**ADDENDUM # 2**

**Bid # 7589558**

**Title: 20 Ton Equipment Trailers**

**Addendum Number 1**

RIDOT Standard Truck Wiring Diagram

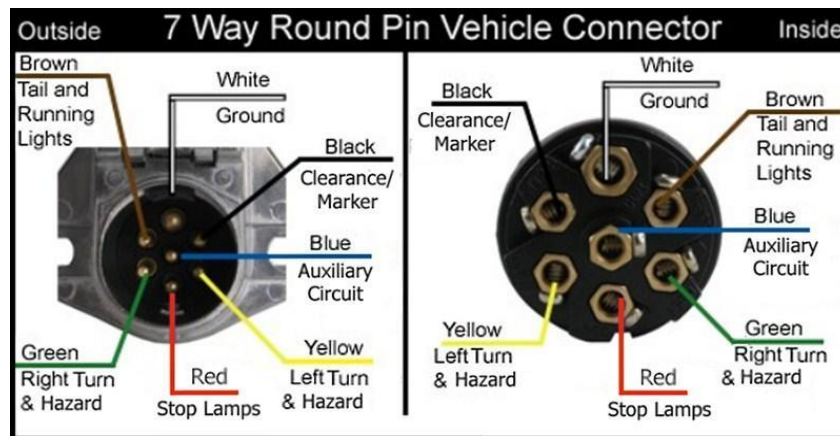
**Add: TRAILER PLUG:**

A trailer plug compatible with RIDOT equipment shall be supplied.

PLASTIC GROTE SOCKET	#82-2145
ACCEPTS PLASTIC GROTE PLUG	#82-2140
